**DEMOLITION OF EXISTING BUILDING ATTACHED TO 20 MARKET STREET,
AND CONSTRUCT A NEW BUILDING FOR GENERAL STORAGE PURPOSES
AT RHOSLLANNERCHRUGOG, WREXHAM, LL14 1AF for D & J THOMAS**

ADDENDUM added 30/03/2016

DEMOLITION OF EXISTING BUILDING ATTACHED TO 20 MARKET STREET, AND CONSTRUCT A NEW BUILDING FOR GENERAL STORAGE PURPOSES AT RHOSLLANNERCHRUGOG, WREXHAM, LL14 1AF for D & J THOMAS		
Prepared by: M.A. Clark. ACIOB	Sections	Scales: 1:50, 1:20
Tel/Fax: 01691 662749	Plan No.2316/08MAC Original Drawing A3

Proposed Elevations Scale 1:100
Plan No. 2316/06MAC Original Drawing A3

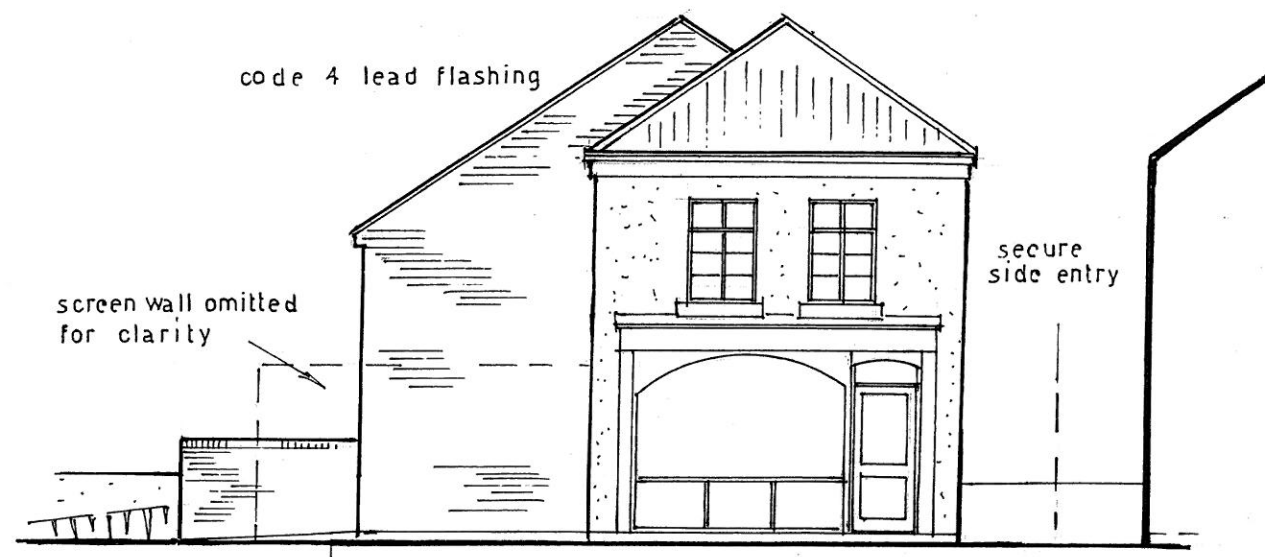
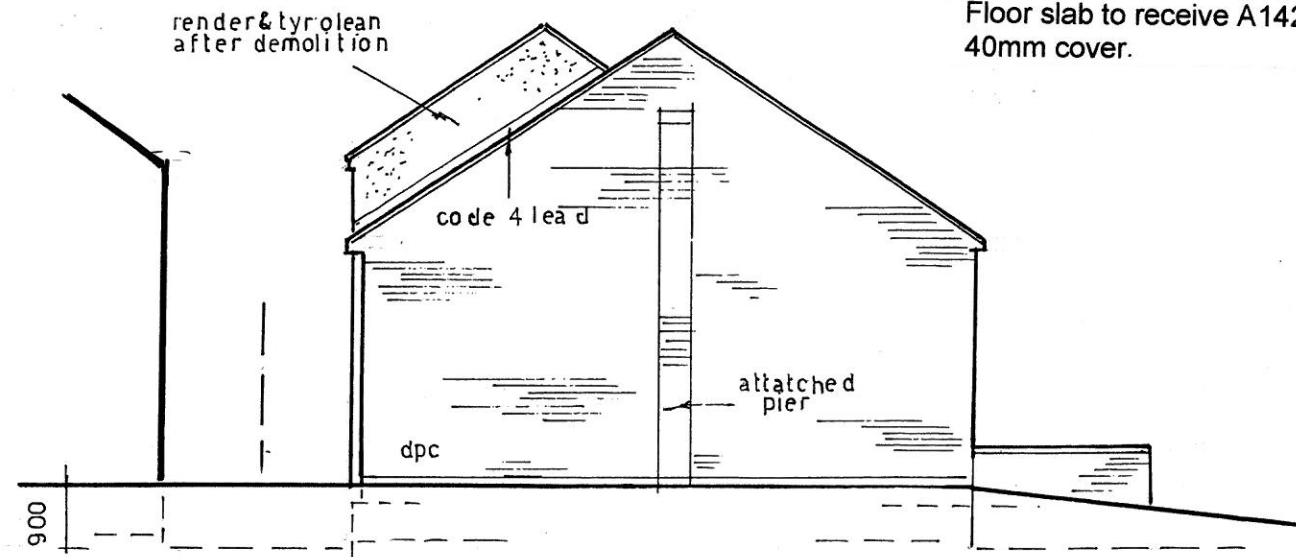
Strip foundations reinforced with 6 - T16 bars on top
And 6 - T16 bars on bottom, with T10 U bars @ 300c/s
Strip foundation increased to 250mm thickness.
Floor slab to receive A142 fabric reinforcement +
40mm cover.

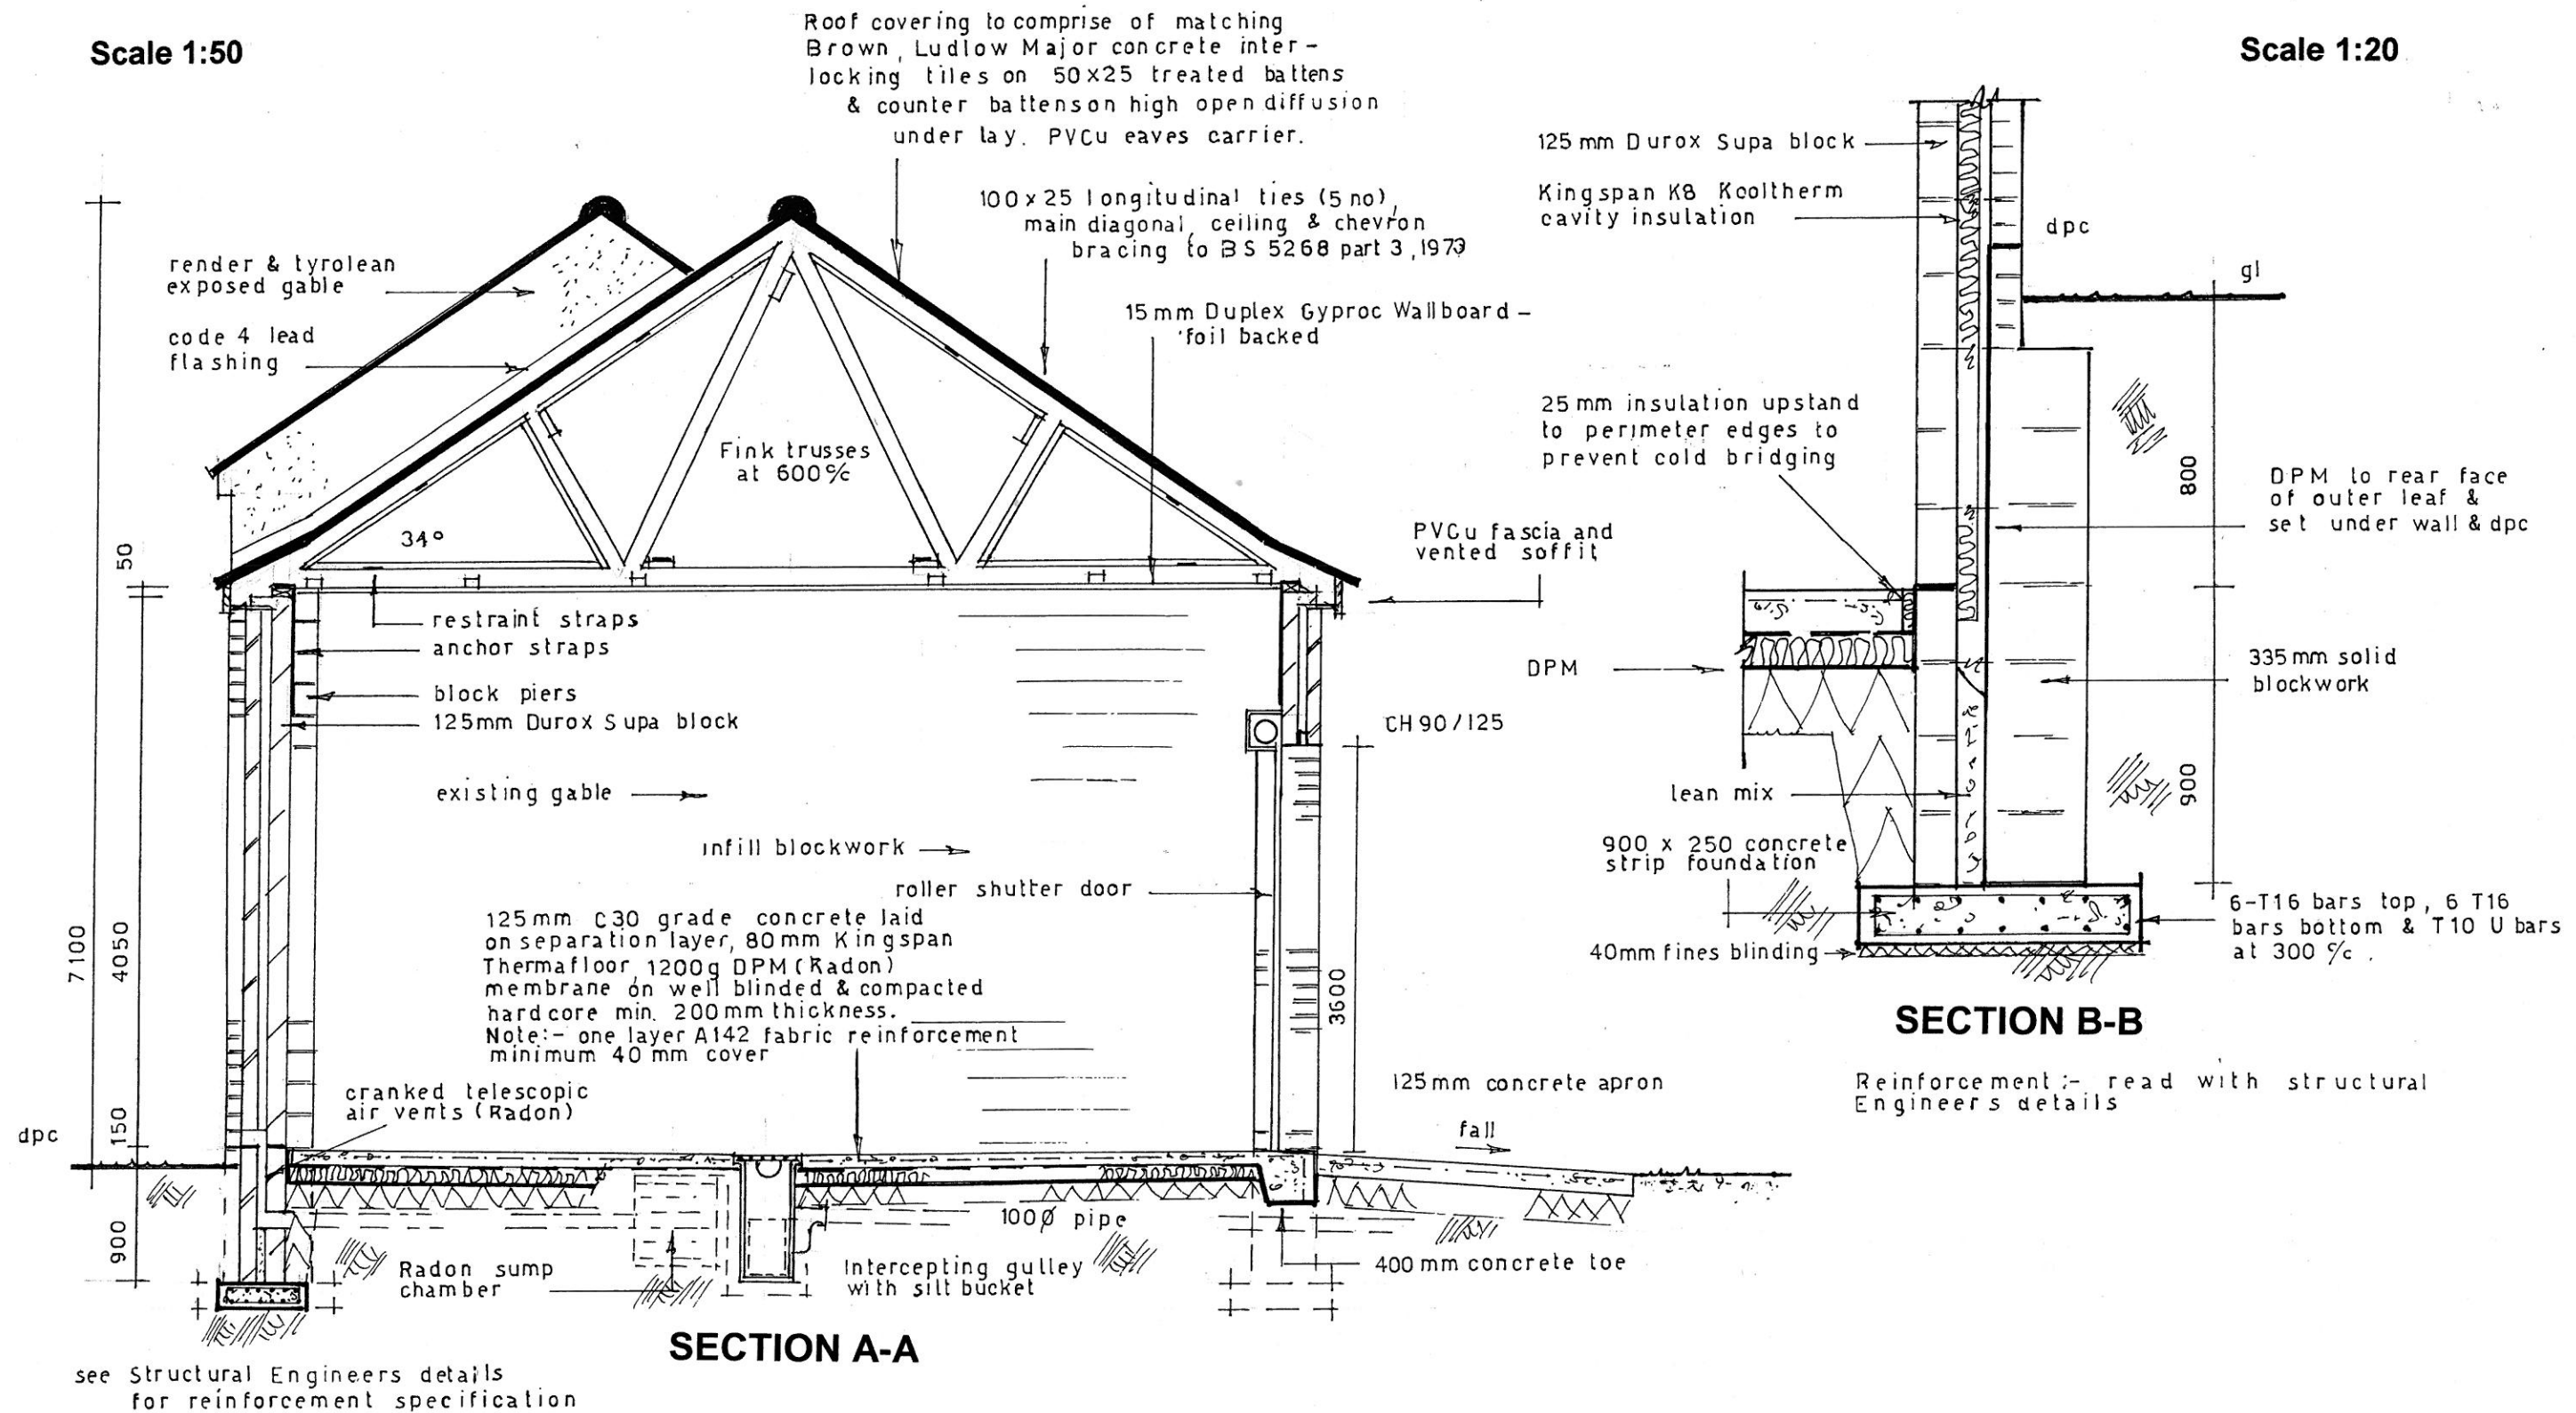
Reinforcement added 30/03/2016
